NOTICE OF NON-PERFORMANCE

INSPECTION REPORT

Electrical Corporation:	SDG&E
Report Number:	NON_ESD_SDGE_RGA_20260210_1149
Inspector:	Ricardo Garcia
WMP Year Inspected:	2025
Quarterly Data Report (QDR) Referenced:	Quarter 3 (Q3) 2025
Inspection Selection:	Energy Safety inspected the locations based on SDG&E’s Q3 QDR.
Relevant WMP Initiative(s):	8.2.3.1 Pole Clearing (WMP.512)
Date of inspection:	February 10, 2026
City and/or County of Inspection:	Ramona, California

Photo 5: Measurement indicates the second eucalyptus stump is approximately eight feet from the base of the pole.

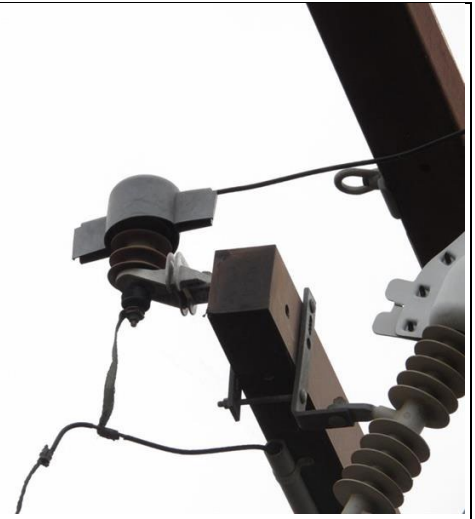
Deficiency 1. Energy Safety observed that in implementing 2025 WMP initiative 8.2.3.1 Pole Clearing (WMP.512) which requires compliance with Public Resources Code section 4292, SDG&E failed to remove all vegetation down to bare mineral soil within a 10-foot radius of pole ID P249734, near coordinates 33.01475, -116.86707. Energy Safety considers this non-performance to be in the Moderate risk category. SDG&E must complete a corrective action for this non-performance by six months from the date of this notice.¹

Energy Safety considers this deficiency "Moderate" because two dead and desiccated eucalyptus stumps remain within 10 feet of pole ID P249734. The continued presence of dry, flammable stumps poses an ongoing wildfire risk.

Within 30 days from the issuance date of this NON, SDG&E must provide a response advising Energy Safety of corrective actions taken or planned to remedy the identified deficiency.
